Tuesday, August 7, 2018
City Council
Meeting

Item H-1

Consider a resolution for a Site Plan of a Jason's Deli, a 4,939 square-foot restaurant with drive-thru, to anchor a single story 9,000 square-foot strip retail building, located on a 1.58-acre lot, on the south side of Keller Parkway (FM1709), approximately four hundred seventy feet (470') west of the Keller Smithfield South and Keller Parkway (FM1709) intersection, being Lot 3, Block E, Keller Town Center Addition, at 1400 Keller Parkway (FM1709), and zoned TC (Town Center). Pinpoint Bear Creek Land Holdings, LLC, owner. Bomac Partners, Ltd or assigns (Trinity Partners), applicant. Thomas Site Development Engineering Inc., engineer. (SP-18-0010)

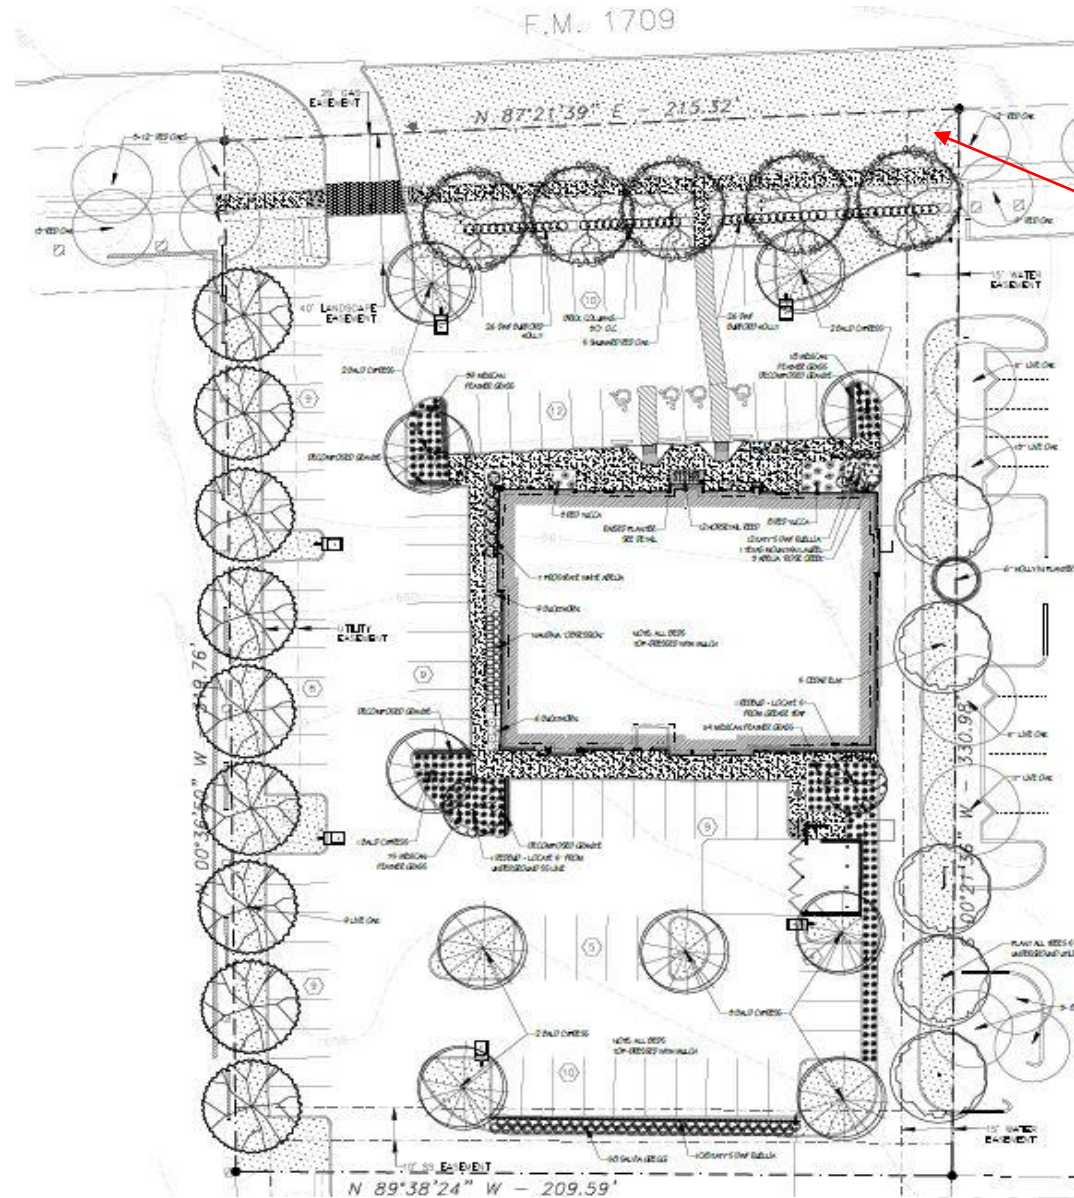
A single row of Red Oak trees is displayed in the Landscape Plan, south of the sidewalk, instead of the Double Row.

The utility easement is owned By Atmos Energy and would not allow trees in the easement. However, staff is still working w/ Atmos to try to get approval for the trees on the north side of the sidewalk.

Variances Requested:

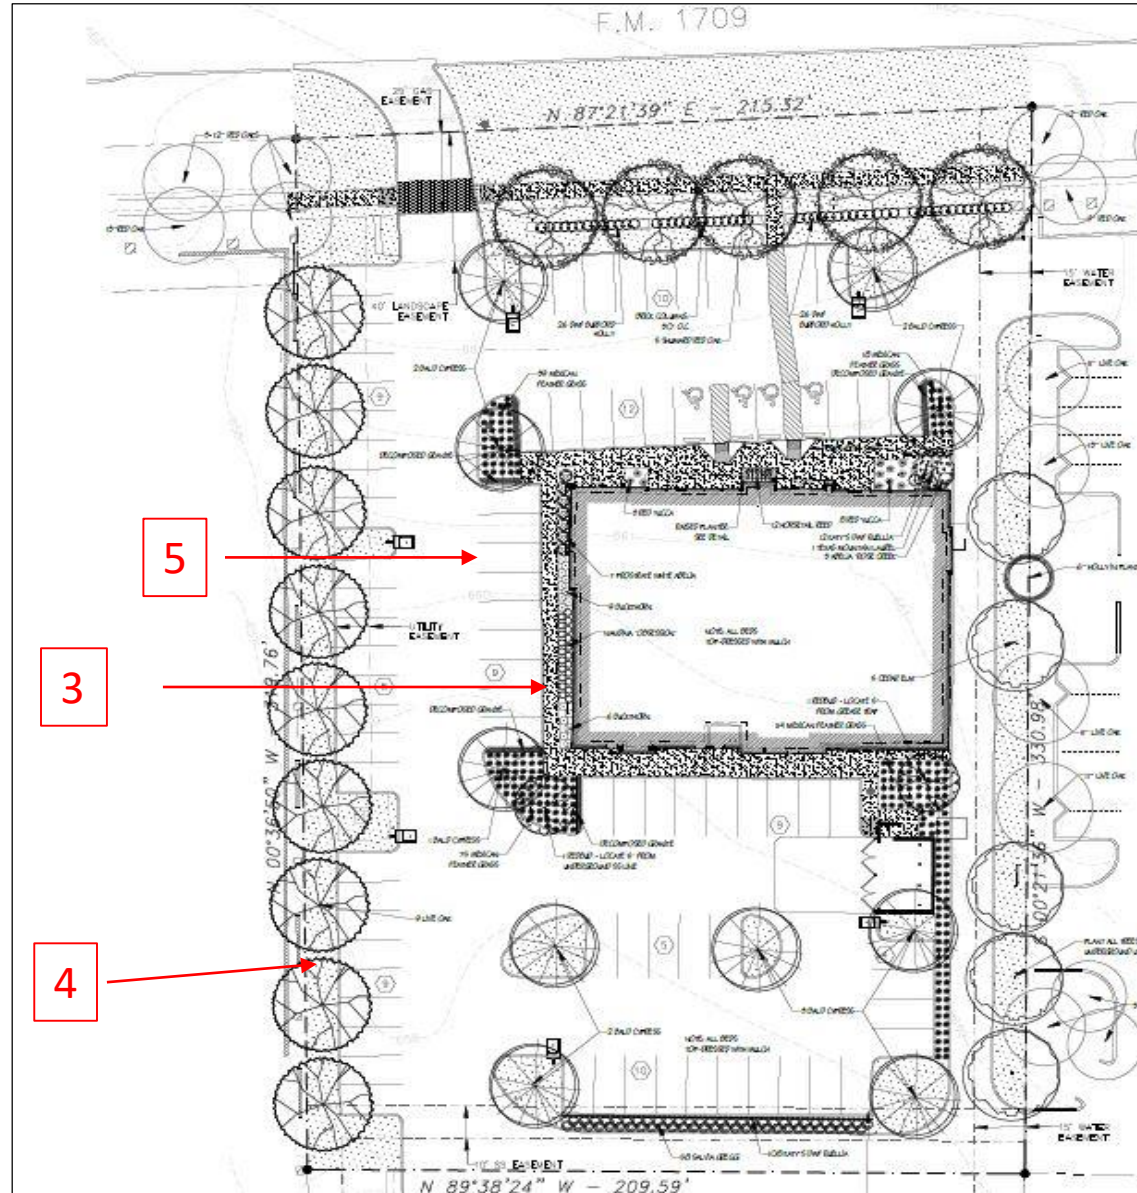
3. 3' foundation landscape planting for a portion of the landscape in lieu of 5' landscape planting.
4. 10' landscape buffer in lieu of 30' buffer.
5. 18' depth for parking space in place of the required 20' depth.

Variances Requested:

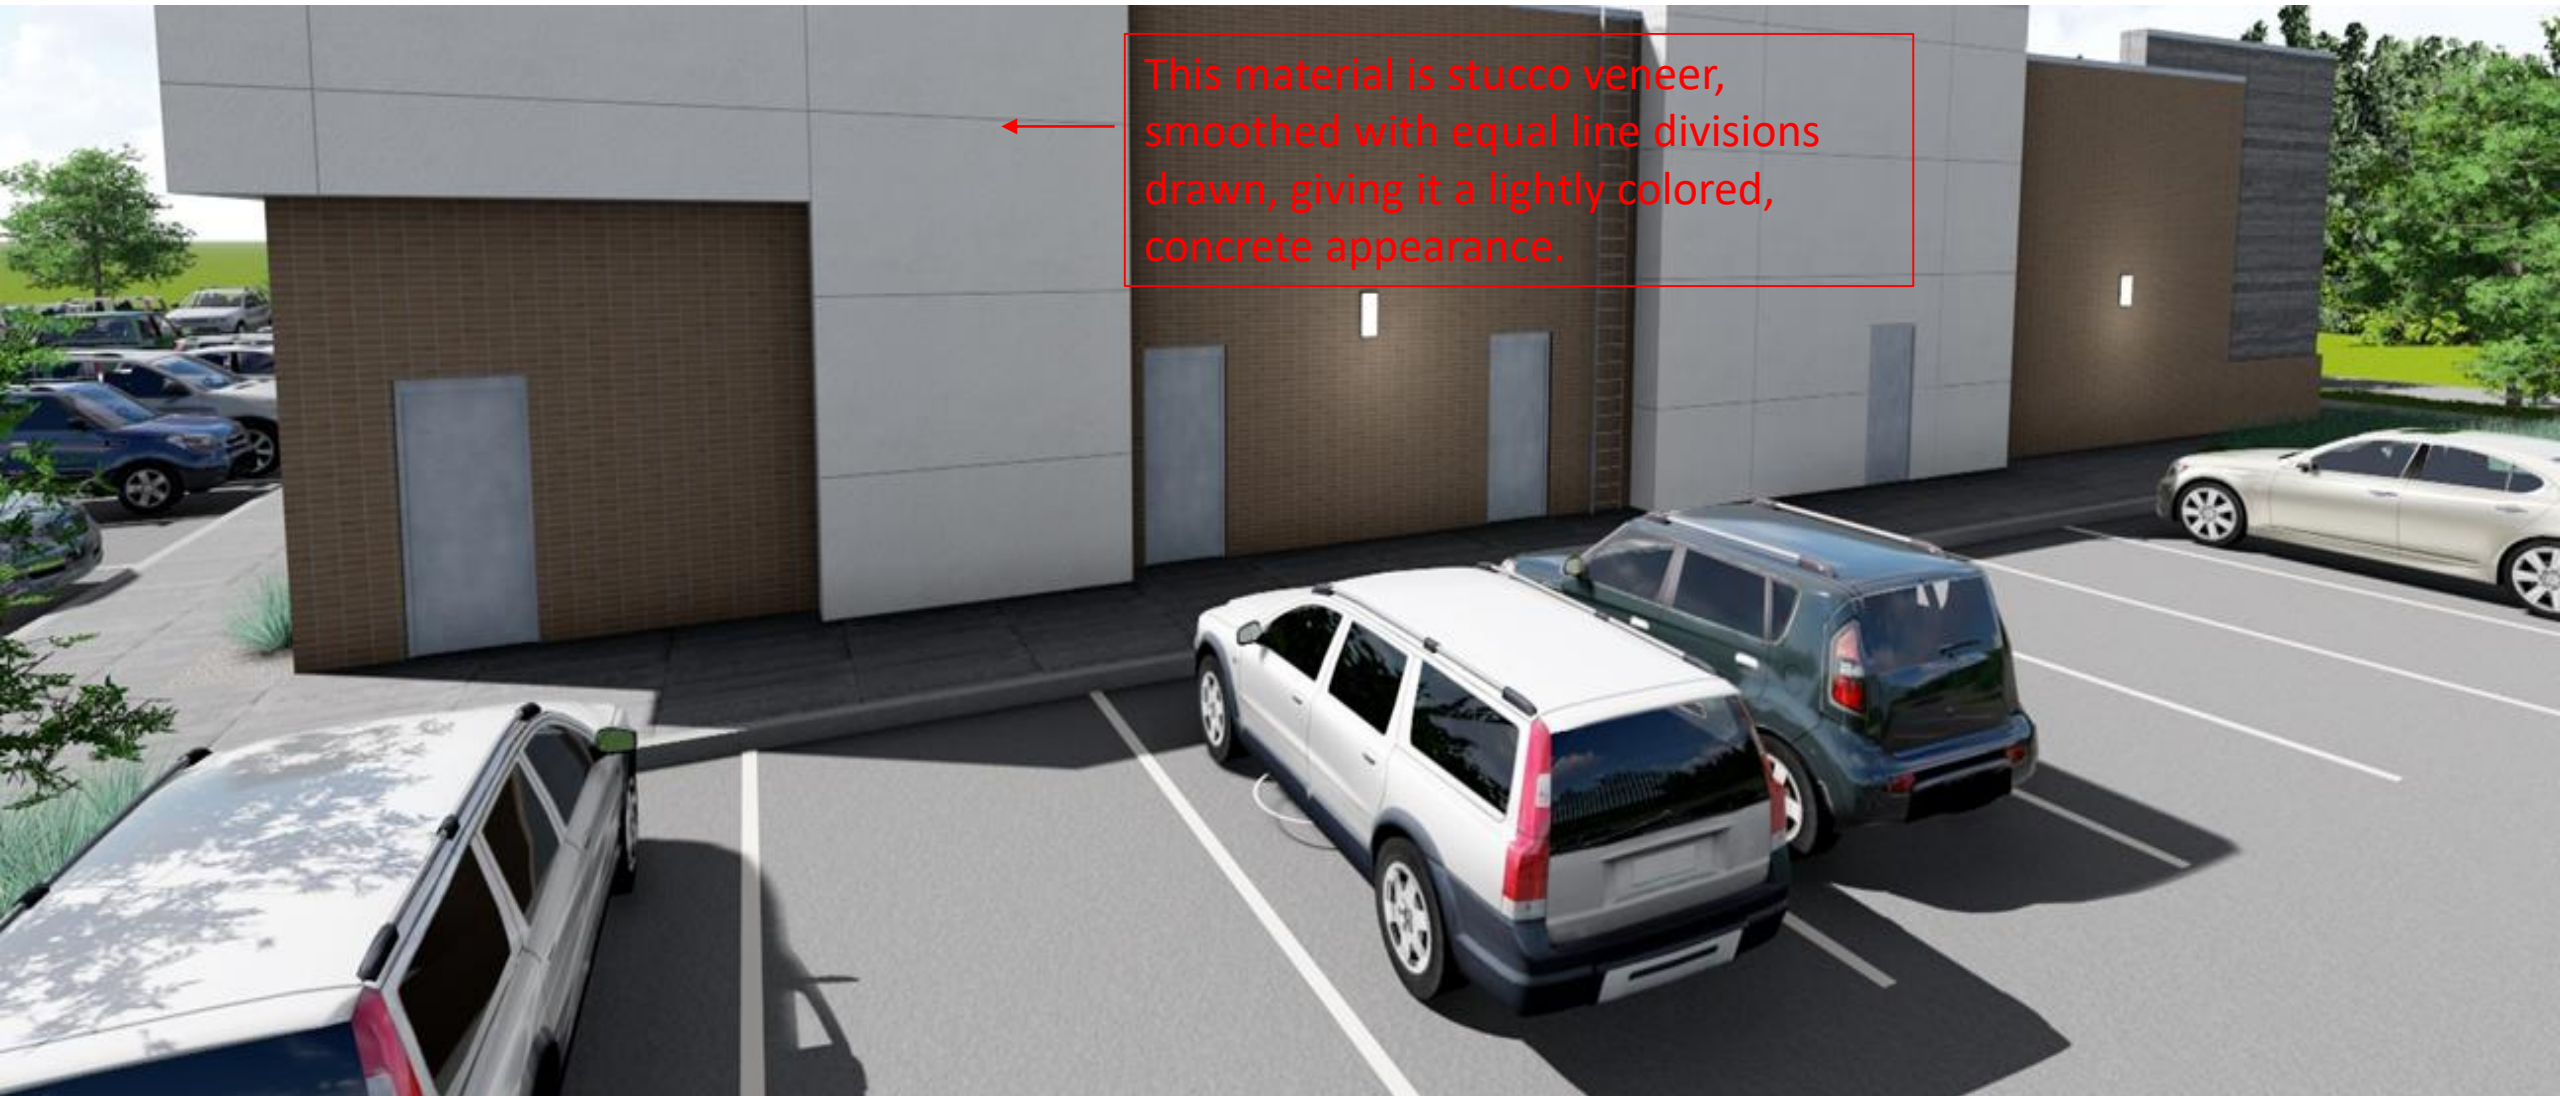
1. Flat roof in lieu of a pitched roof.

2. Building material (Brick, stone, or cast stone) at 49% in lieu of 75%

North Elevation

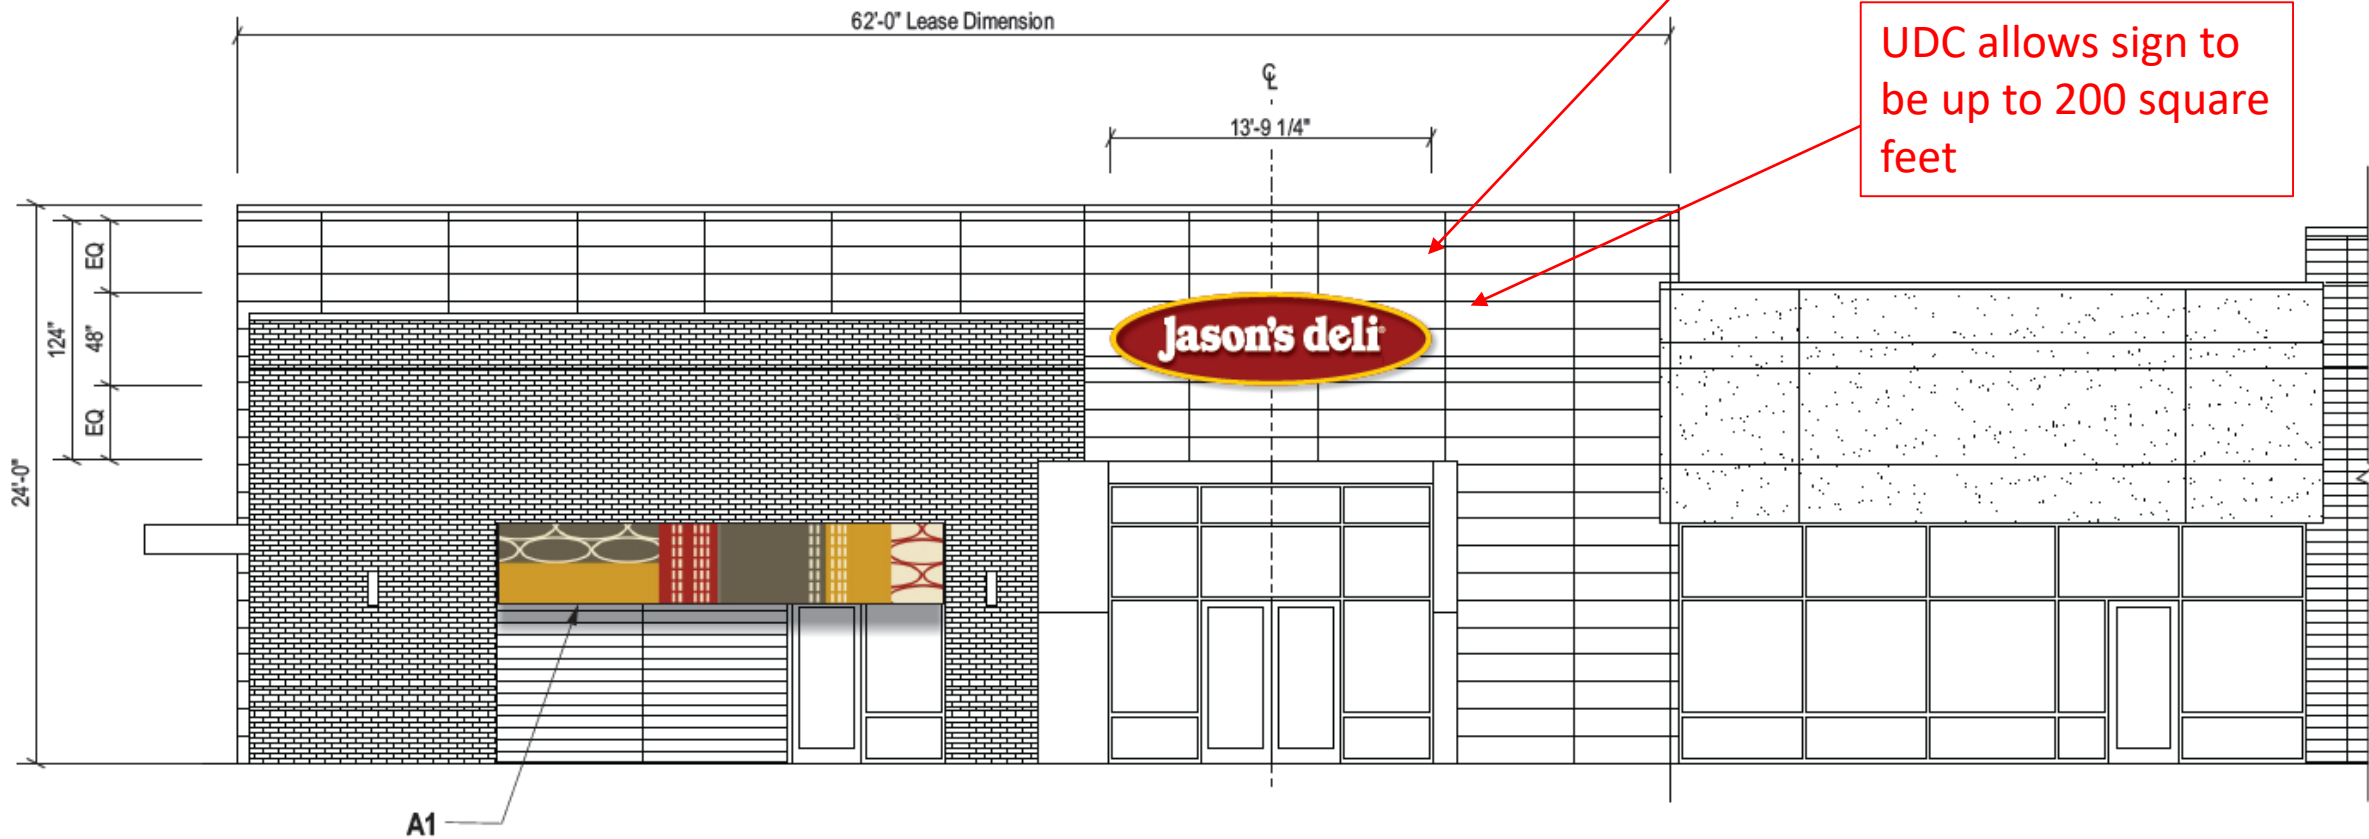
Sign shown is 55.08 square feet and approximately 48 inches in height

UDC allows sign to be up to 200 square feet

East Elevation

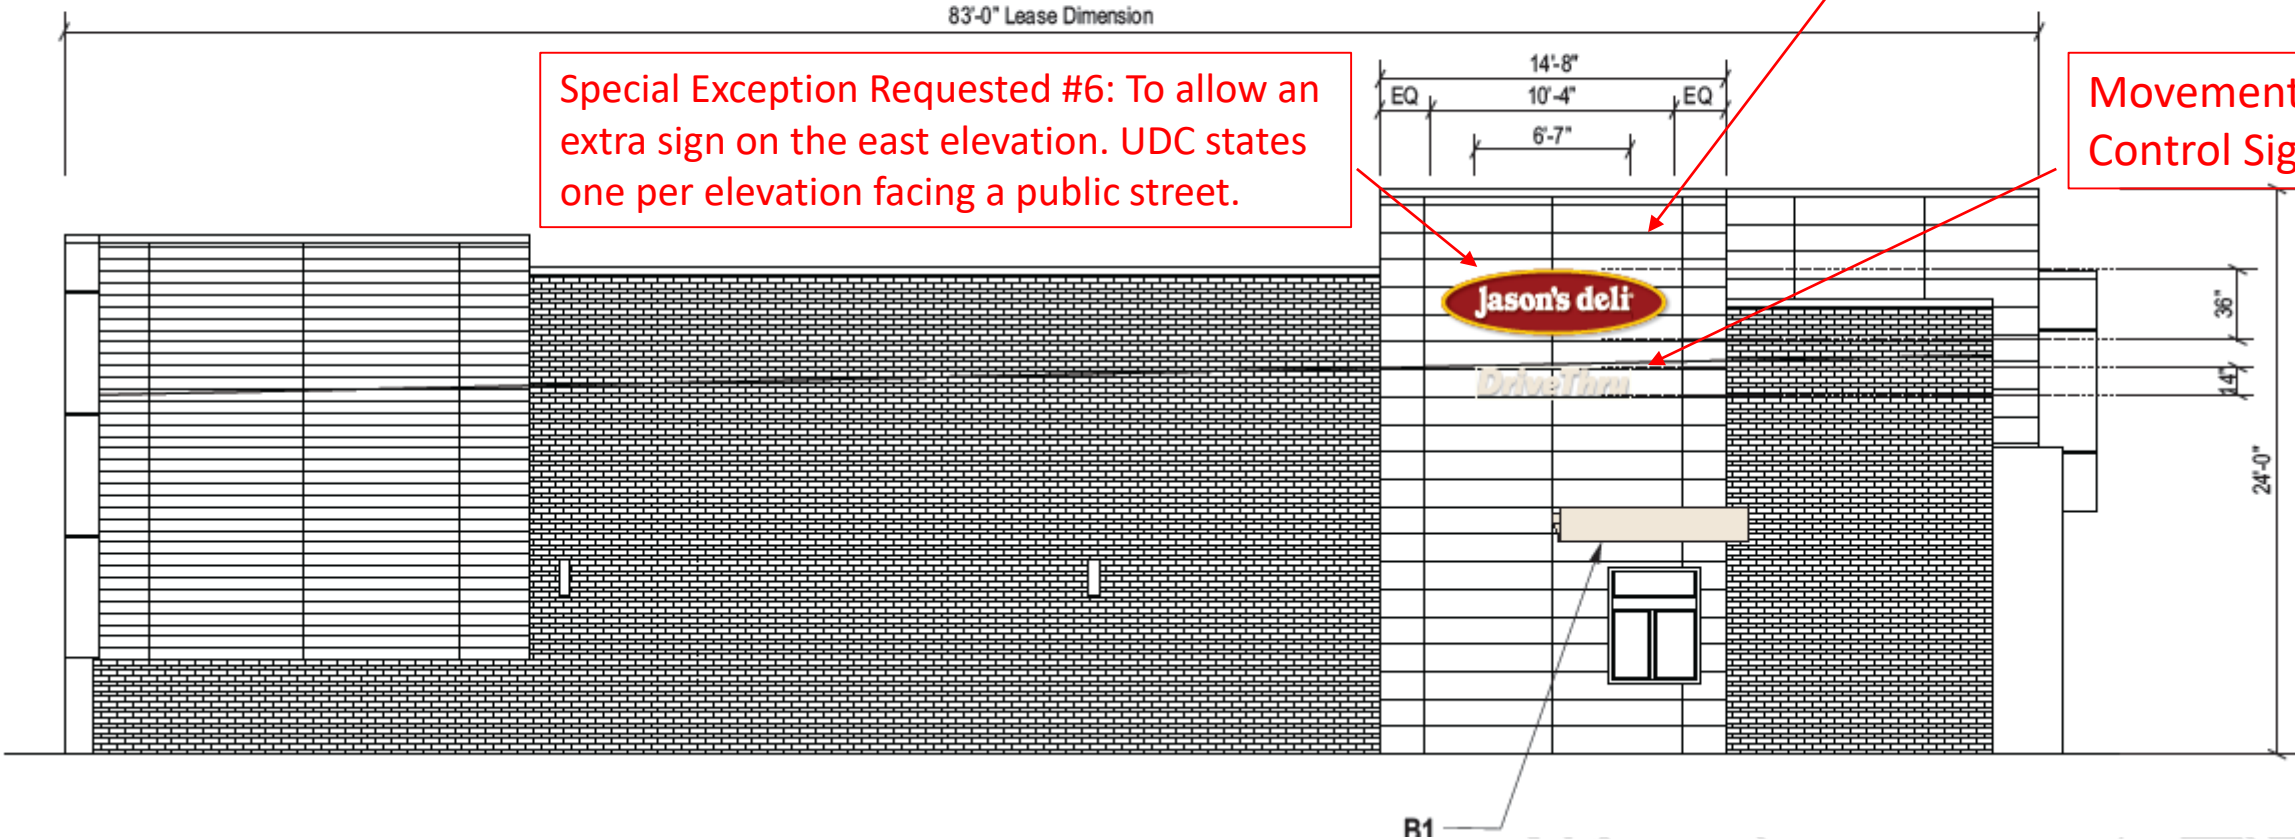
Attached sign approximately thirty – one square foot with a height of thirty-six inches.

Special Exception Requested #6: To allow an extra sign on the east elevation. UDC states one per elevation facing a public street.

Sign Layout Detail

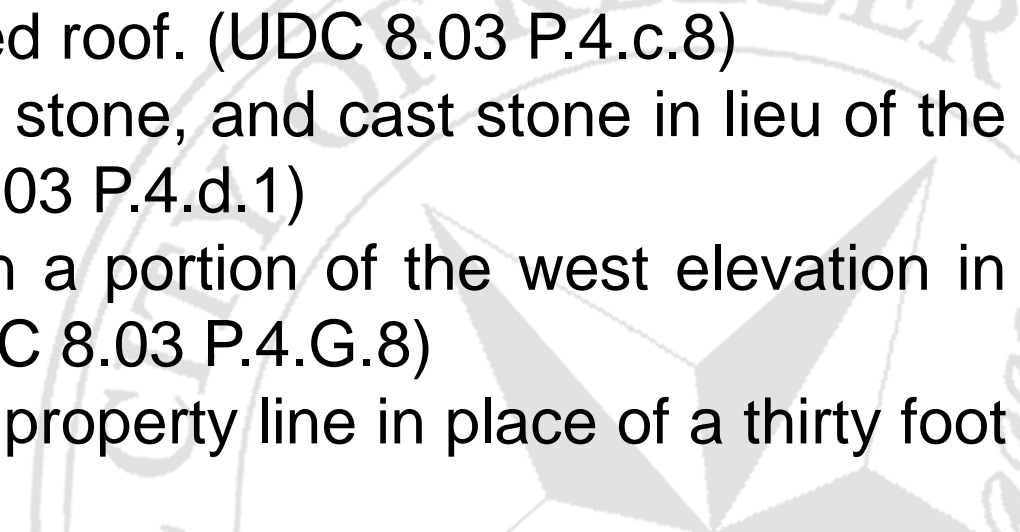
Movement Control Sign is approximately 7.68 square feet and 14” in height.

Special Exception Requested #7: UDC states sign cannot exceed 6 square feet and 4” in height. Sign is 7.68 SF and 14” in height.
